**Tyres: UN Regulation No. 141 (Tyre pressure monitoring systems)**

### **Proposal for a new 01 series of amendments to UN Regulation No. 141**

#### **Submitted by the Task Force on Tyre Pressure Monitoring System and Tyre Installation\***

**Figure 1**  
Refilling check.

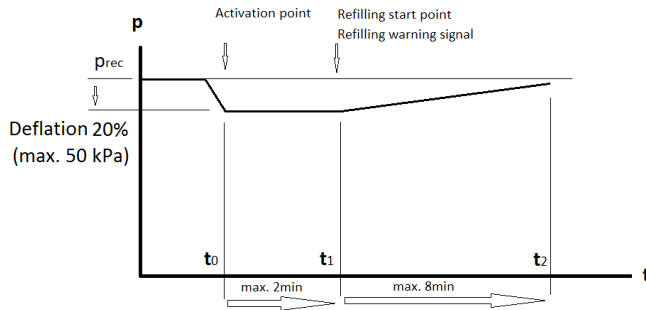
- 2.2.1. Check refilling according to Figure 1

Refill process shall be completed within 8 min after the refill process has started and the optical signal for refilling as described by the manufacturer shall be OFF as soon as the refilling process is completed.

After the refilling process has been completed, check that the tyre pressure is in a range of +/- 5% of manufacturers recommended cold inflation pressure  $P_{rec}$ .

**Figure 2**  
Checking system malfunction warning functionality.

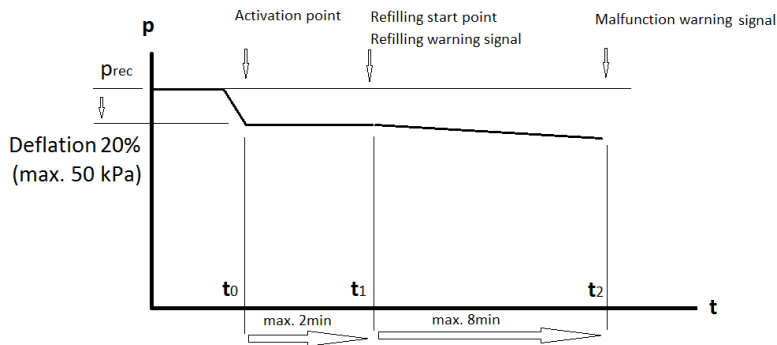
- 2.3. Check system malfunction warning functionality according to Figure 2
  - Inflate the vehicle's tyres to the vehicle manufacturer's recommended cold inflation pressure ( $P_{rec}$ ).
  - Constantly deflate the system or the pressure of one tyre by 20% but not more than 50 kPa below the manufacturers recommended cold inflation pressure ( $P_{rec}$ ).
  - Within 2 min the system shall start refilling and the optical signal as described by the manufacturer for refilling is be ON
  - Within 8 min after the start of the refilling the optical signal for malfunction as described by the manufacturer shall be ON.
